ECE/TRANS/WP.29/2008/66
10 April 2008

Proposal for Supplement 6 to Regulation No. 106
(Tyres for agricultural vehicles)

Submitted by the Working Party on Running Gear (GRRF) */

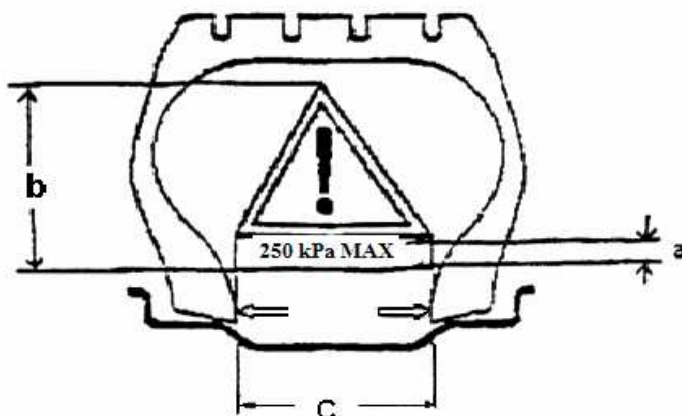
Annex 11, replace the existing pictogram by the following:
